CCK-2564.0-18-26 HEB BP-07

ADDENDUM #3

UK Construct Health Education Building
ADDENDUM No. 3
CCK-2564.0-18-26
08/1/2025

E-111

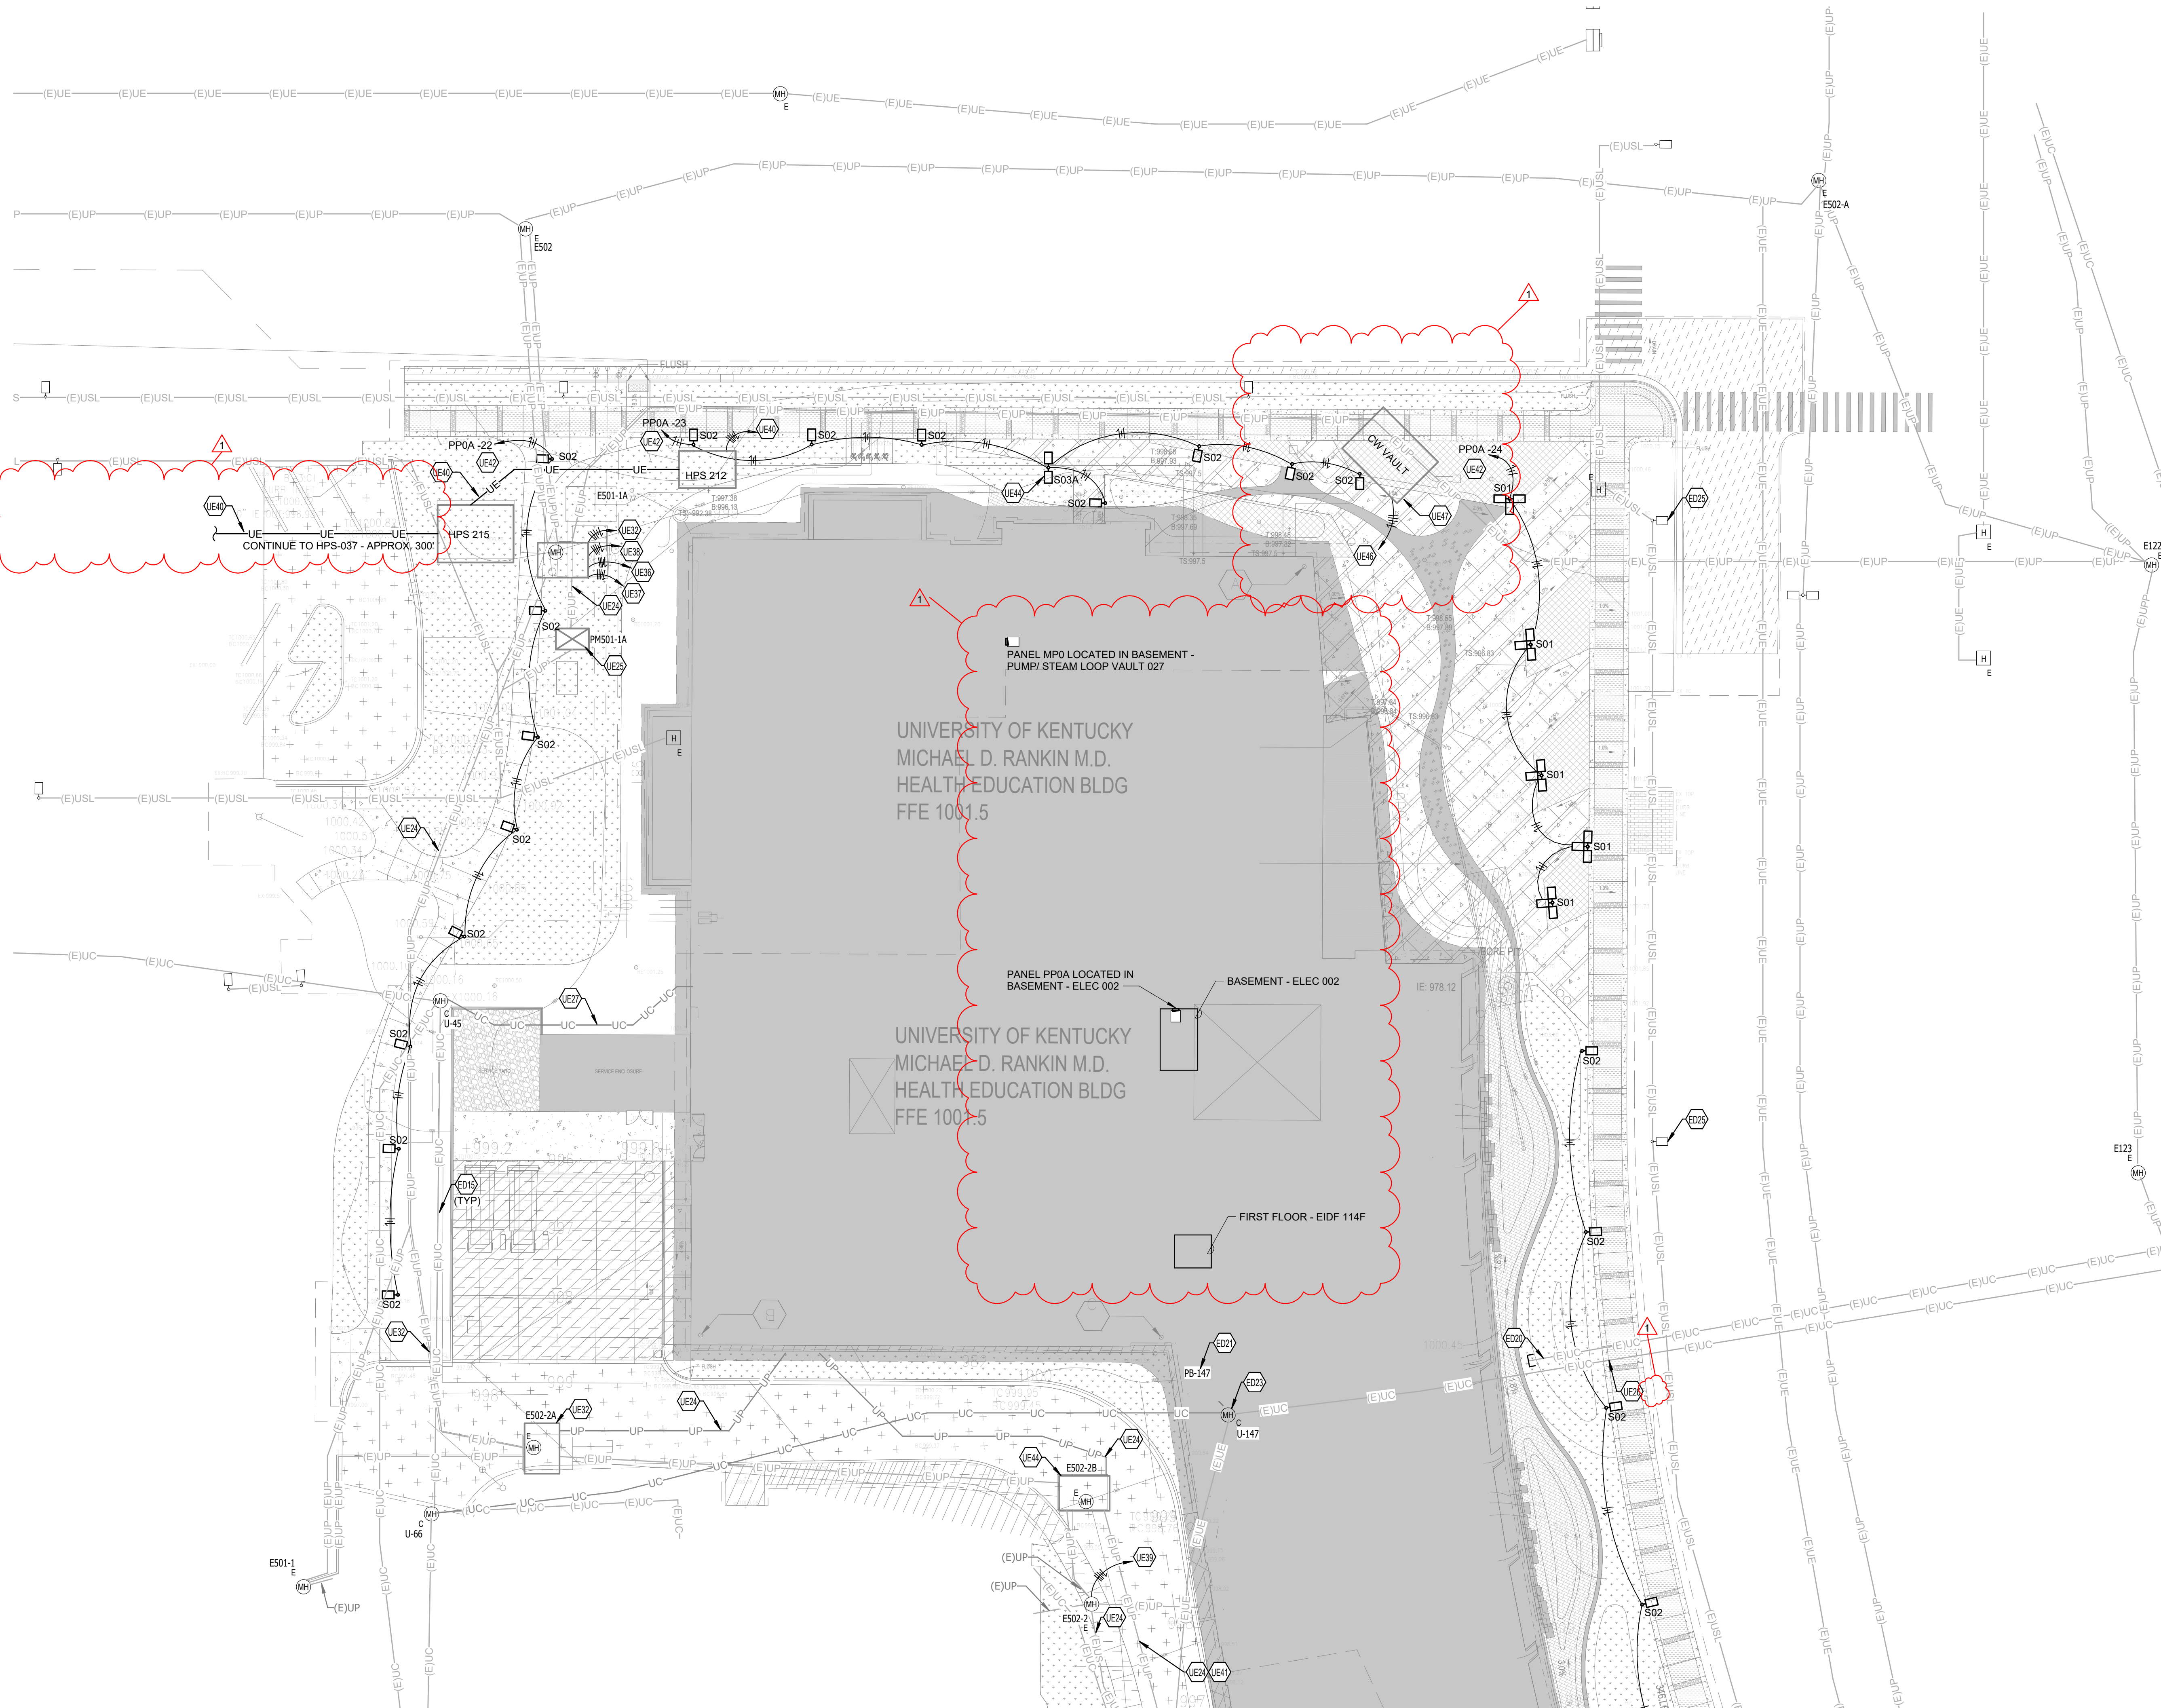
Refer to attached Drawing E-111 BP-07 ELECTRICAL PLANS AND SCHEDULES for changes including:

- a. Added notes clarifying location of panels supplying courtyard lighting.
- b. Added note clarifying conduit install requirements for courtyard lighting fixtures.
- c. Revised tagged notes to provide clarity on lighting control requirements.

5 CHILLED WATER VAULT POWER DETAIL
SCALE: NONE

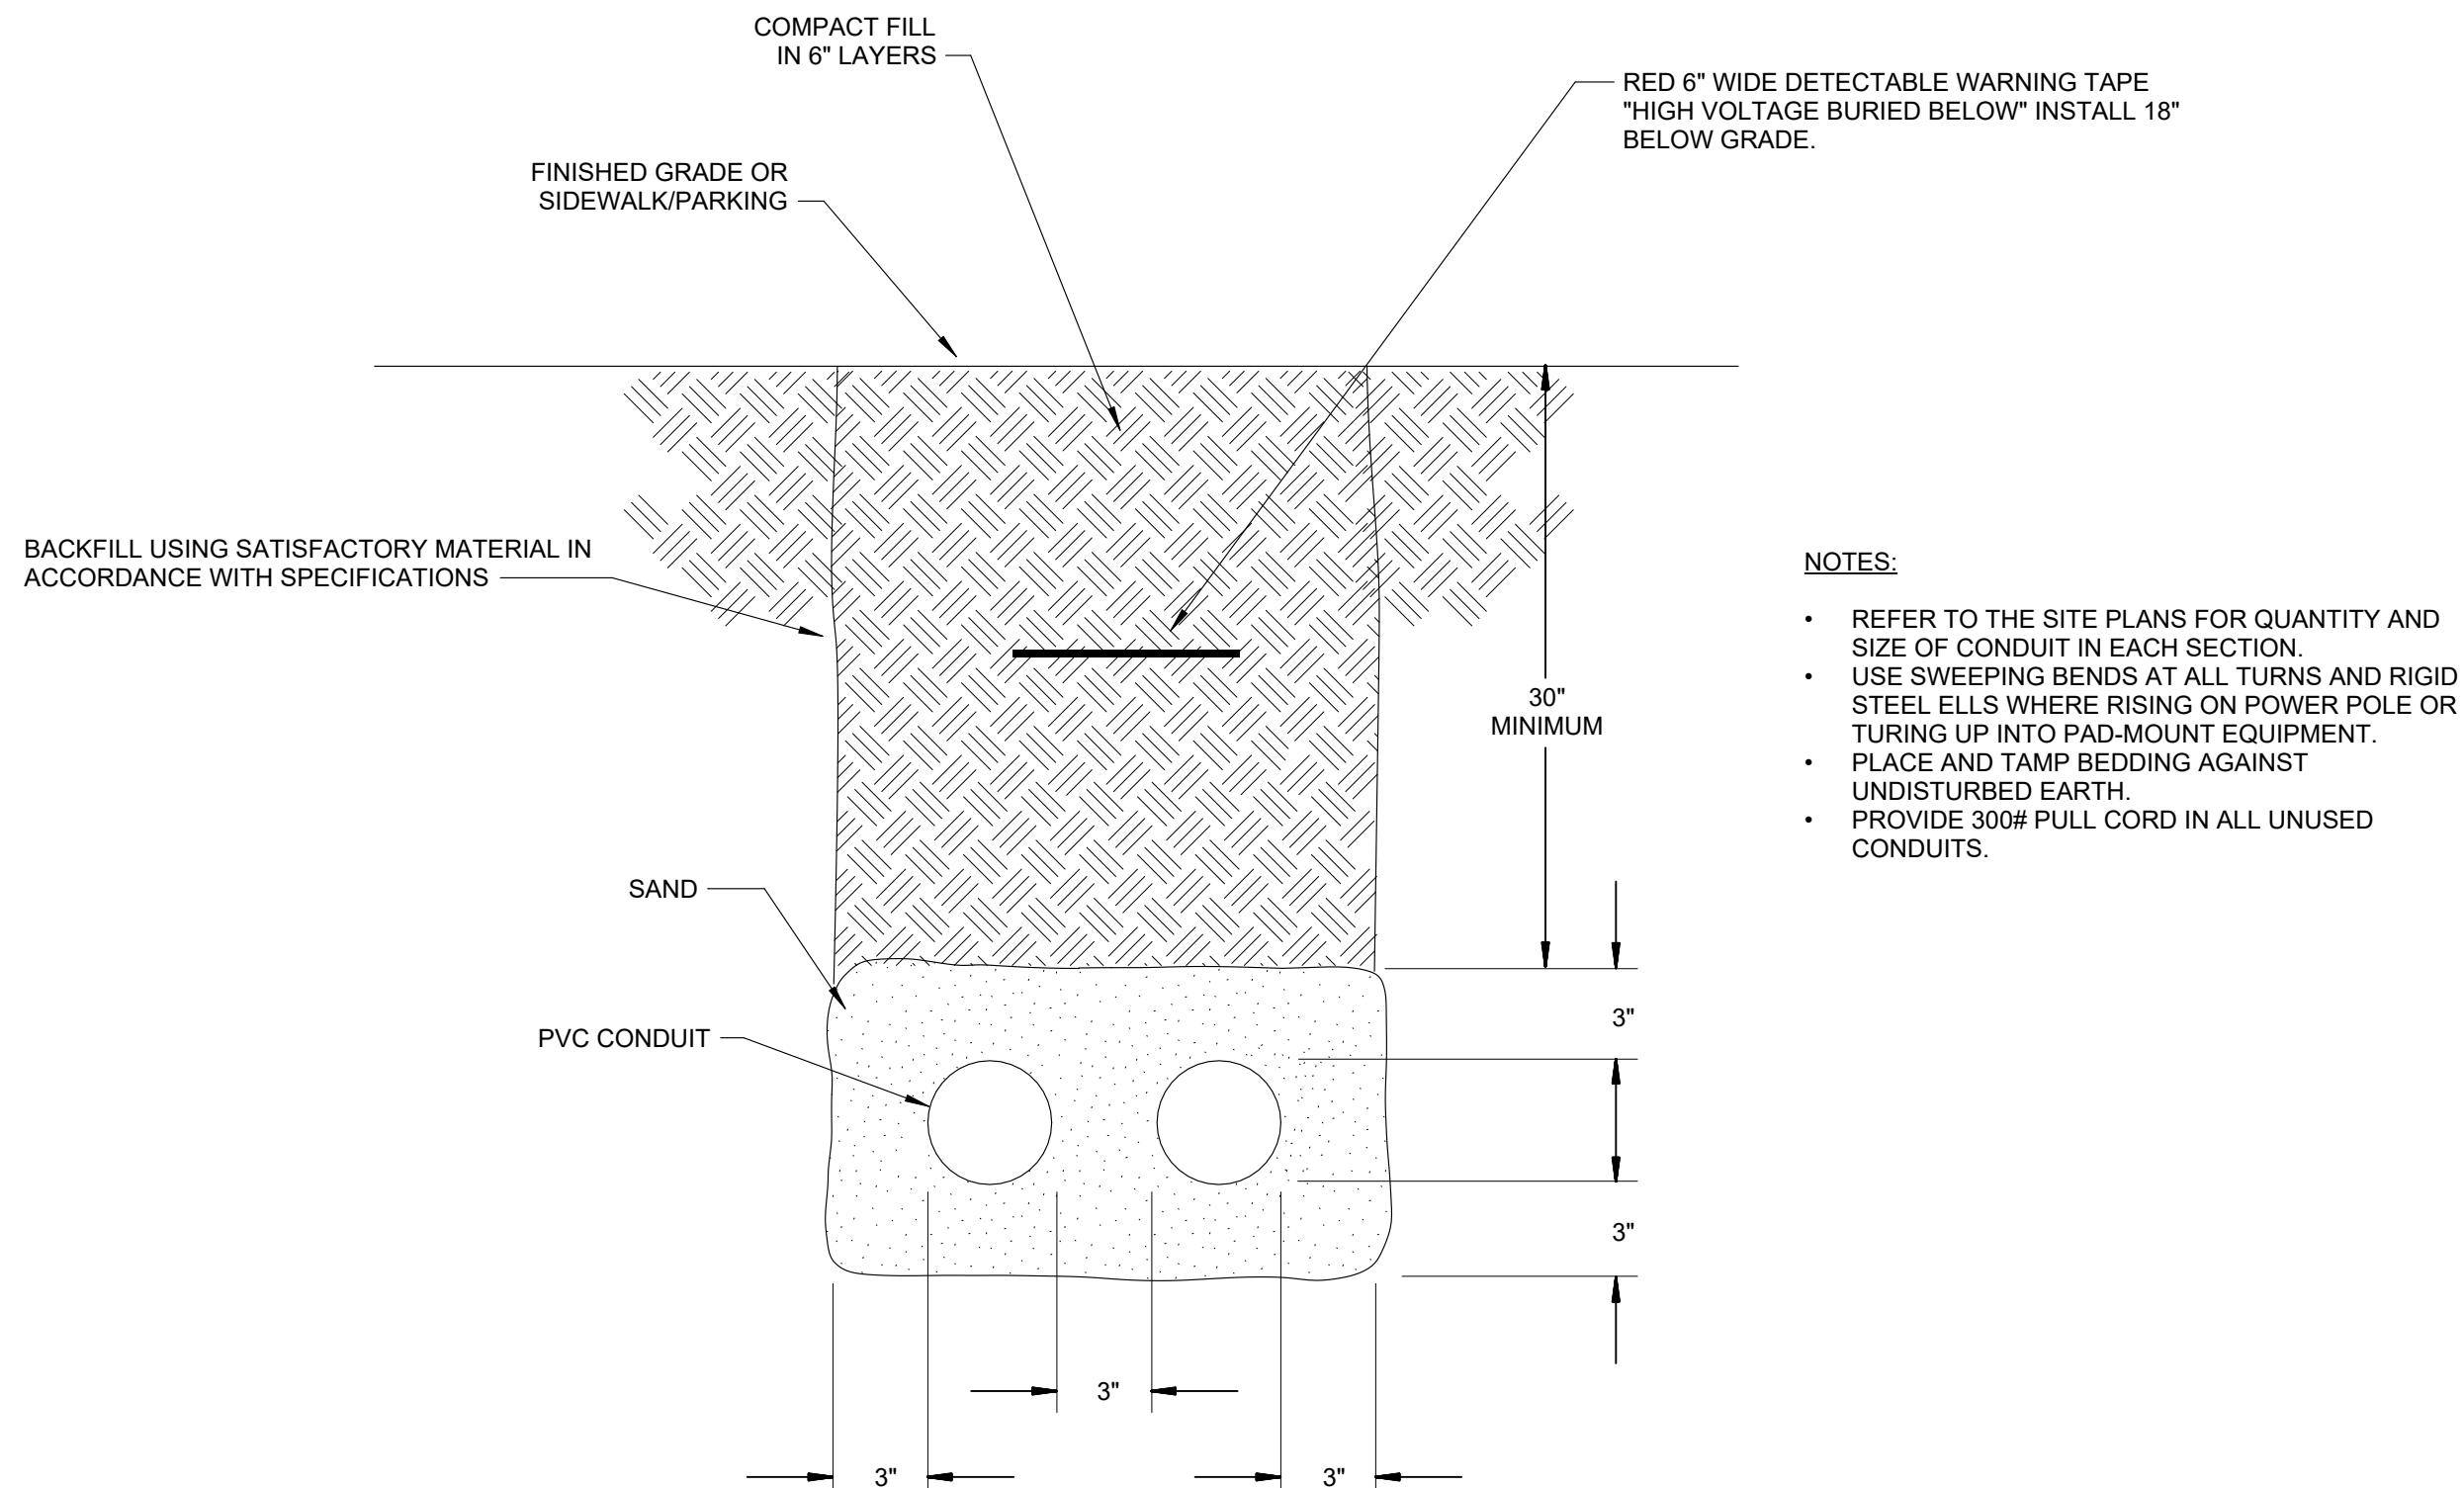
Refer to attached Drawing EU510 - ELECTRICAL SITE DETAILS for changes including:

- a. Added chilled water vault power detail.
